# Technical Service Information

## FORD ATX

### 2-3 SHUDDER

Figure1

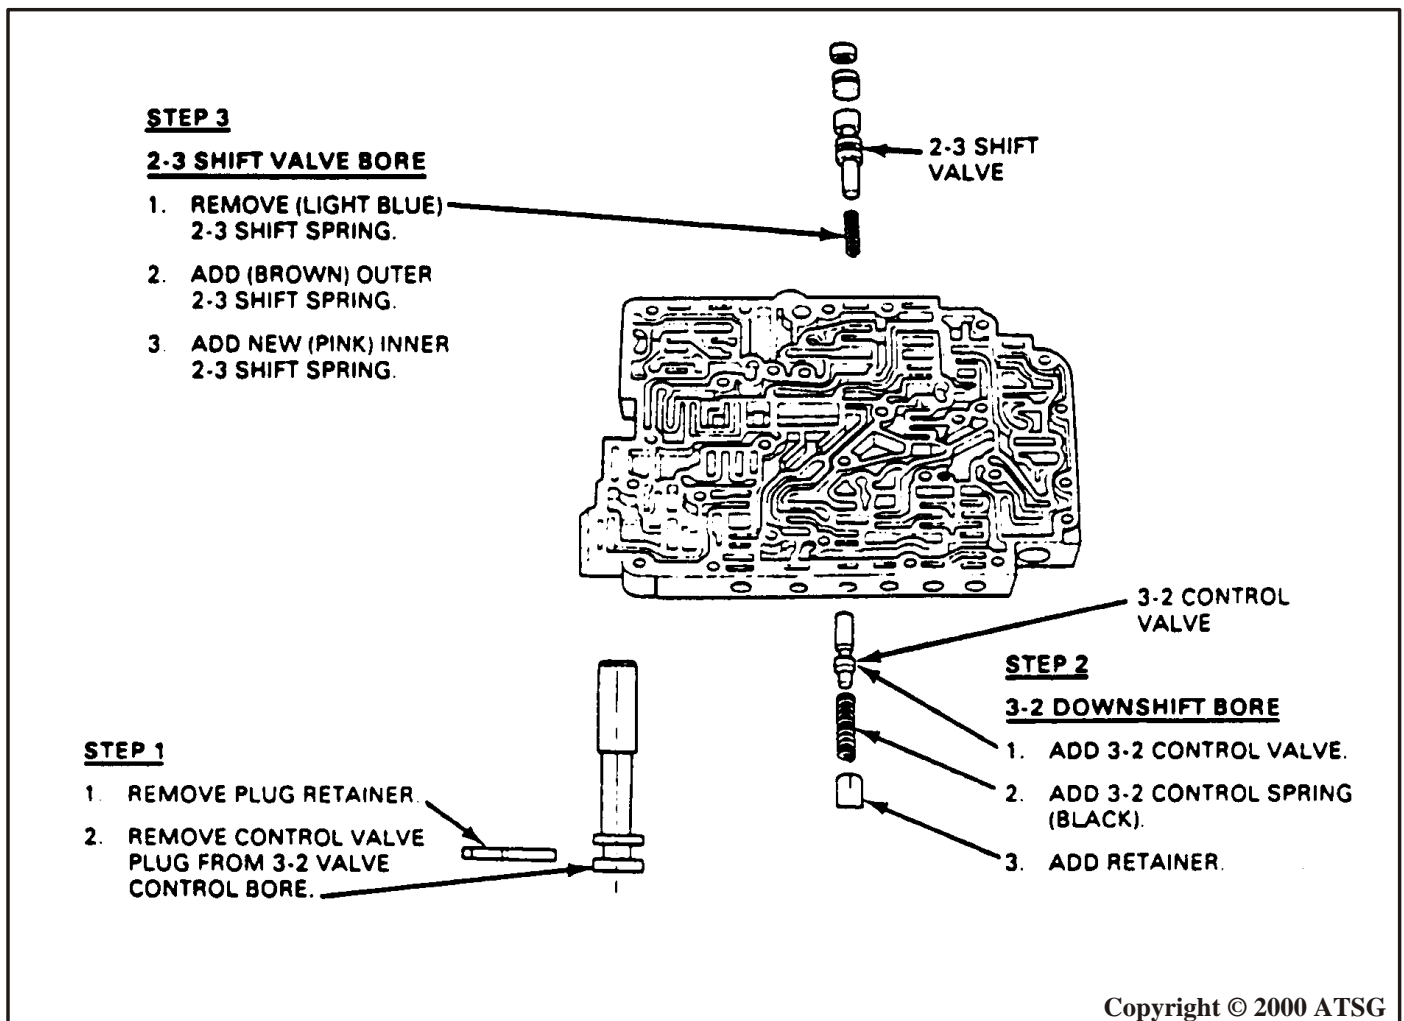
**COMPLAINT:** A low speed shudder and/or boom while driving in third gear.

**CAUSE:** The cause may be shift point variances in the 2-3 upshift and the 3-2 downshift pattern.

**CORRECTION:** Install a new design main control service kit, OEM part number E6F'Z-7A230-A, that revises the part throttle 2-3 upshift and 3-2 downshift pattern. Refer to the following procedure.

1. Remove and discard the 3-2 control valve plug and retainer. (See Figure 1)
2. Install the new 3-2 control valve, control valve spring, and flat plate retainer from the main control service kit. (See Figure 1).
3. Replace the 2-3 shift valve spring with the two spring "Nested" assembly from the main control service kit (See Figure 1).
